CELL :- A315 **CELL NAME:-** Oil Pump **MACHINE / STAGE:-** Supplier End(ACMA) **OPERATION :-** Casting

KAIZEN THEME :-To Reduce the % of Blow Holes In A315 Casting .

IDEA :- Robust Design of Runner & Gate.

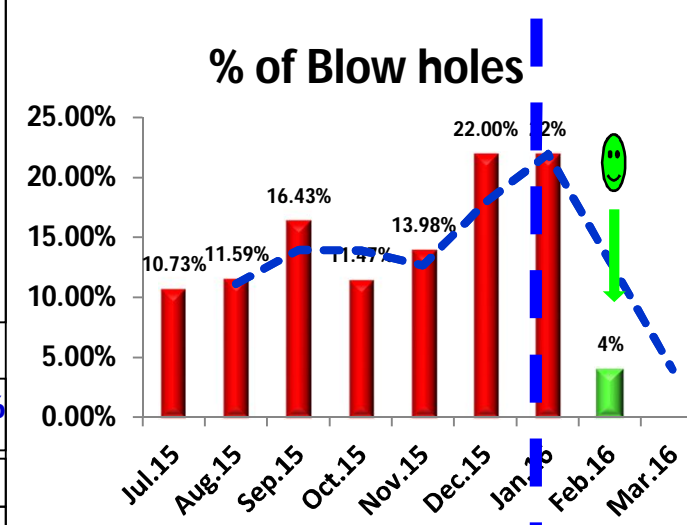
PROBLEM / PRESENT STATUS: 16 % of A315Casting Found with Blow Holes After Machining.

WHY - WHY ANALYSIS :-
Why 1 : 15233 No's A315 Casting Body .Found With Blow Holes after machining.
Why 2 : Air Entrapped in cavity.
Why 3 : Insufficient Material Flow.
Why4 : Weak Design Of Runner & Gate.
ROOT CAUSE :-Weak Design Of Runner & Gate.

COUNTERMEASURE:1) 1)To improve the design of Gate By changing the Gate design From Split Type To Fan Type.
